MEMO

- From: Christine Trebellas, AICP, AIA, LEED Green Associate Vivian C. Majtenyi, AIA, NCARB Historic Preservation Consultants
- Date: November 1, 2022, revised
- Re: 83 S High Street; Informal Review of October Submittal, Preservation POV

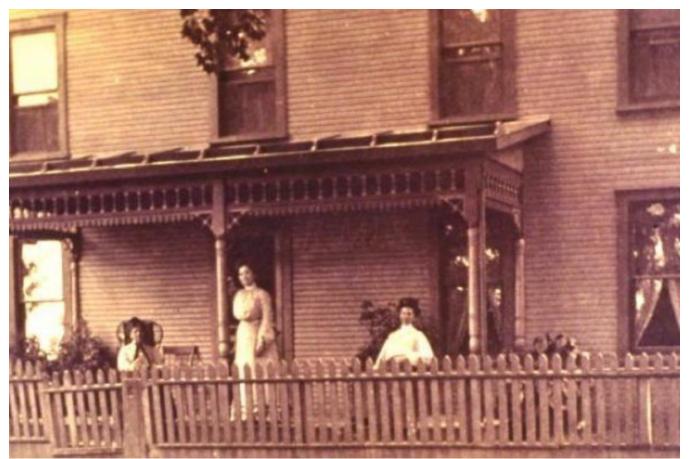
has a low gable roof between the higher gable of the garage and the cross gable of the "cottage" portion of the proposed addition. gable roof. Overall, this area needs more attention; the laundry room bump-out feels awkward, especially on the north elevation. And the roof intersections feel forced—especially the laundry room and the cottage portion of the proposed addition. In addition, the area north of the garage and west of the "cottage" portion of the addition needs definition. It is unclear how this area will be treated (as well as how shared access to the neighboring properties will continue). Are there large windows or doors from the "cottage" portion leading to this area? Hopefully this will be resolved in a future submittal.

Moreover, some of the addition elements have a complexity that could benefit from being simplified. For example, the laundry room could be reduced in size and the bump out could be smoothed out. As mentioned above, the roof plan needs some work. The "cottage" portion's north/south gable seems to be too close, too parallel to the lean-to's roof. Instead, try increasing the space between the "cottage" portion of the new construction and the existing lean-to addition. Or consider using a taller element to run East/West on the southern portion of the addition, between the Master Bath and the Laundry Room; provided it can be subordinate to both the I-House and the lean-to historic addition.
